Answers to Questions – 3/29/2023:

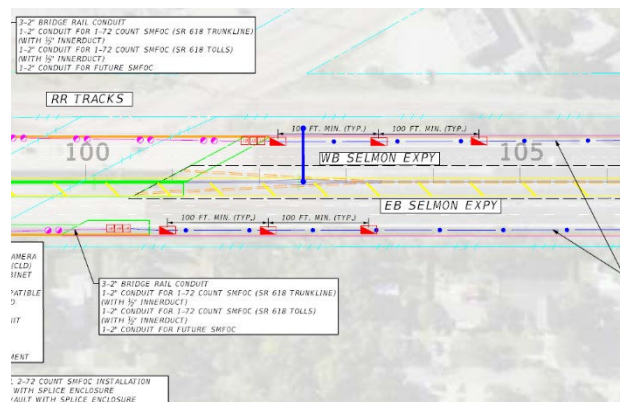
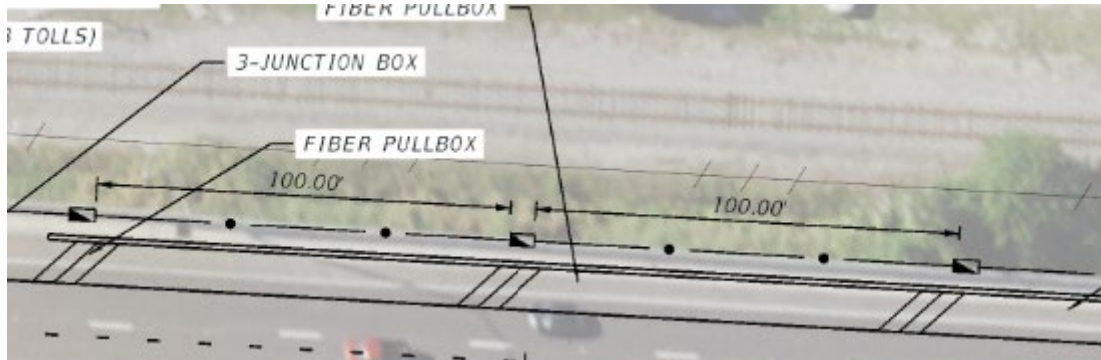
1. The Pond Siting Report (PSR) show the Spanish Creek Basin (Station 244+04 to High Point of Bridge over Willow Avenue) discharging to its historic outfall, a 24-inch pipe under the CSX at Station 252+88. However, the Concept plans show the Spanish Creek Basin being diverted to the Swann Avenue Pond, located in the Rome Avenue Basin. This is due in part to the right-of-way constraints north of Station 252+75, where the minimum clearance between the retaining wall and the LA R/W line decreases from 13.75' to 2.75'. Therefore, maintaining the existing conveyance system or modifying it is not feasible without obtaining an easement from the CSX.

Has this diversion of stormwater runoff to and how it will impact the Rome Avenue Basin been discussed with and approved by the City of Tampa (COT) and the Southwest Florida Water Management District (SWFWMD)? The additional runoff to the Swann Avenue Pond will impact the COT storm drainage system on Swann Avenue and the COT outfall system from the pond on Rome Avenue.

Answer: THEA is coordinating with the City of Tampa regarding construction of the new South Howard outfall. Information will be provided to the DB Firms as soon as it is available. An amendment will be issued requiring the DB Firm to model all existing and proposed stormwater basins and outfall systems impacted by the project. The drainage and stormwater network shall meet the City of Tampa criteria which requires the 25-year/24-hr post-development rate attenuated to 5-year/24-hr pre-development rate at each connection to the city system and if not feasible (i.e. within existing THEA ROW) to providing as a minimum, quantifiable improvement or a quantifiable determination of no adverse impact to the existing City systems to their discharge point at the bay.
